SERVICE 		1
		B0100022

SB, 225 H, 225 HBV, Crankcase, 2001-03

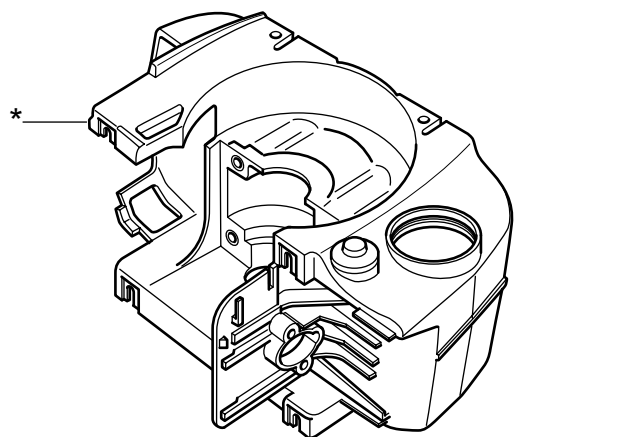
A new crankcase with plugged holes for the fuel pump (air-purge) is now available. This crankcase should be used on older machines without a fuel pump, manufactured up to 1997.

Also included with the crankcase is a fuel cap with venting valve, as the tank venting is moved from a separate venting valve to the fuel cap.

Up To Serial Number 7129999

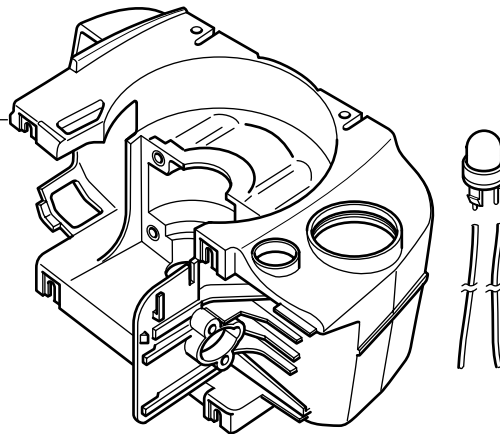
On machines with a fuel pump, manufactured from 1998, the earlier crankcase 503 77 11-04 should be used.

New part number	Description	Old part number	Remarks
503 77 11-05	Crankcase complete	{ 503 77 11-03 503 77 11-01

***compl 503 77 11-05**

*503 82 80-04

501 27 82-01
